## Suspension Hitting LP Pipe

HRV is issuing this documentation to resolve an issue that has arisen. There is a possibility that the suspension equalizer can hit the LP pipe mounted on the I-Beam of the frame. This document contains the information necessary to move the LP pipe to prevent damage.

2011 Caliber models within the VIN range of 5SFNB3523BE224085-5SFNB3126BE227987.

Location of LP pipe mounted on frame.

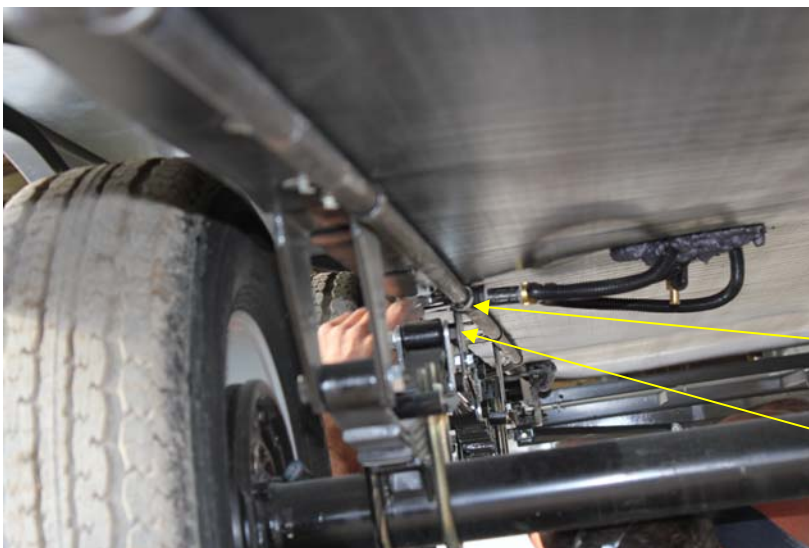
1. Verify the distance of the LP pipe in relation to the equalizer on the suspension. If the LP pipe is mounted on the outside of the I-Beam no repair is needed. File claim for inspection.

Location of equalizer with potential to hit LP pipe.

Location of hanger brackets

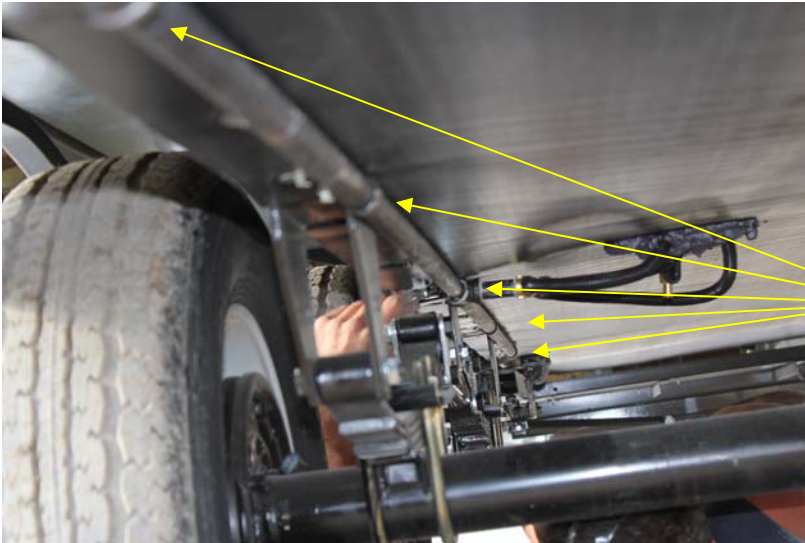
2. If LP pipe needs moved, remove the hanger brackets located along the frame before and after the axle area. If the LP pipe is damaged and needs replaced you must contact customer service before the repair. Add warranty code 04-06-02 B to your claim for .30 hrs.

Location of frame tabs.

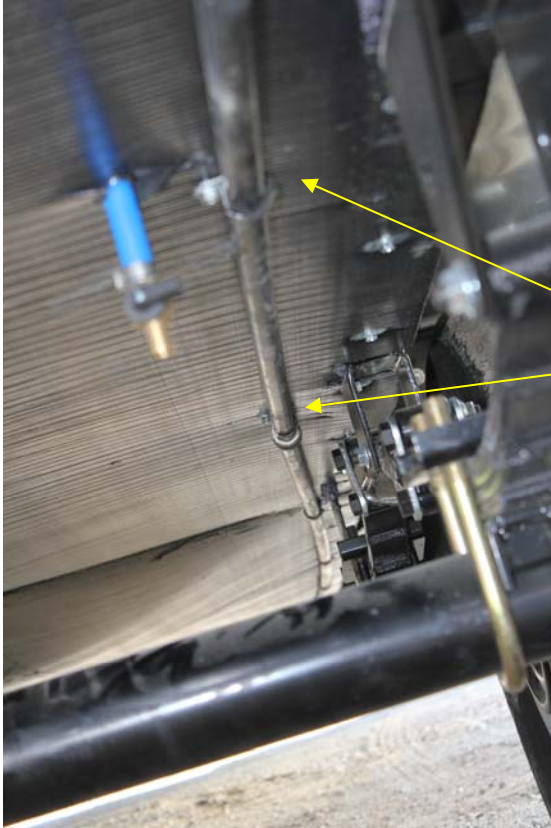
3. Using the provided floor plan print locate the tabs mounted on frame under the underbelly.

4. Pull the LP pipe away from the frame and re-secure using the same bracket and screw to the metal tabs on frame.

Corrected location of LP line.
